<b>Docket Number:</b>	18-IRP-01
<b>Project Title:</b>	Integrated Resource Plan
<b>TN #:</b>	229408
<b>Document Title:</b>	Staff paper - Review of the City of Redding's 2018 Integrated Resource Plan
<b>Description:</b>	N/A
<b>Filer:</b>	Harinder Kaur
<b>Organization:</b>	California Energy Commission
<b>Submitter Role:</b>	Commission Staff
<b>Submission Date:</b>	8/13/2019 3:34:47 PM
<b>Docketed Date:</b>	8/13/2019

# **Review of the City of Redding's 2018 Integrated Resource Plan**

August 2019 | CEC-200-2019-010

**Figure 1: Redding and Energy Commission Energy Forecasts 2018 — 2030 (GWh)**

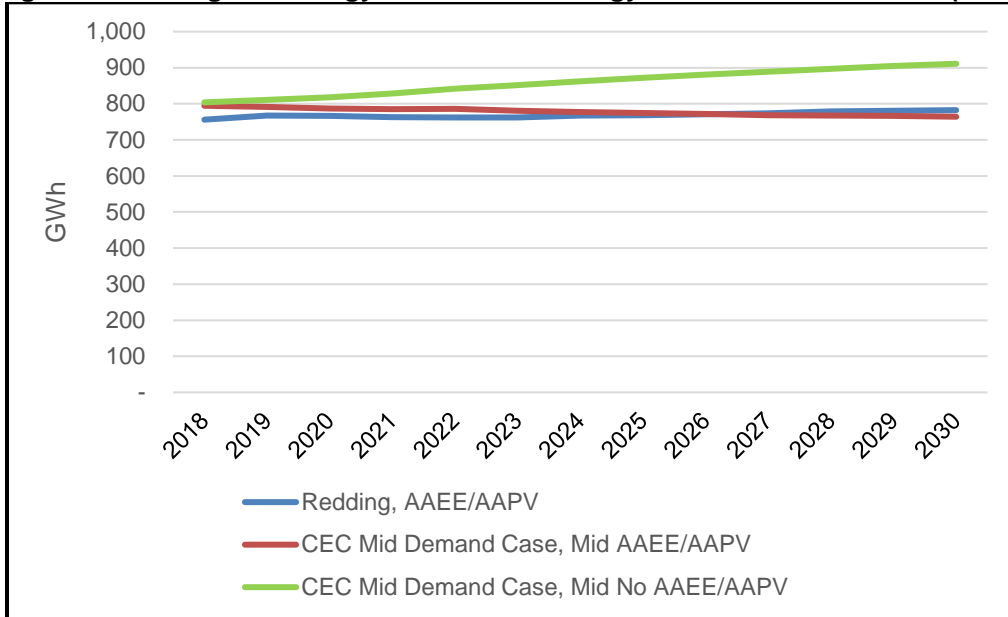
In **Figure 1**, Redding’s net energy increases slightly from 767-GWh in 2019 to 782-GWh in 2030. For the system, this is a 4 percent growth over the planning period. The Energy Commission forecast is comparable to Redding’s forecast for 2030, ending at 764-GWh (Mid AAEE/AAPV). The small differences between the forecasts can be attributed to how energy efficiency is calculated and incorporated into the models.

**Figure 2: Redding and Energy Commission Peak Forecasts 2018 — 2030 (MW)**

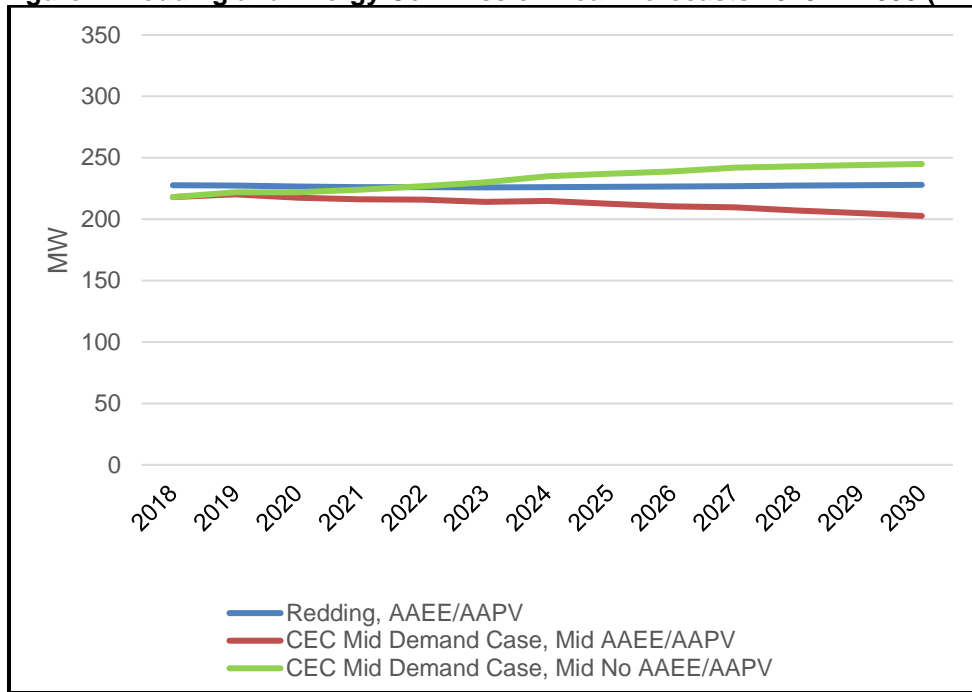
In **Figure 2**, Redding forecasts a peak demand that differs slightly from the Energy Commission’s. Redding’s peak demand is flat: 227-MW in 2019 to 228-MW in 2030, while the Energy Commission’s shows a slow decline from 218-MW to 203-MW (Mid AAEE/AAPV) over the same period. A contributing factor for the difference may be the way weather data is normalized across the two forecasts.<sup>10</sup>
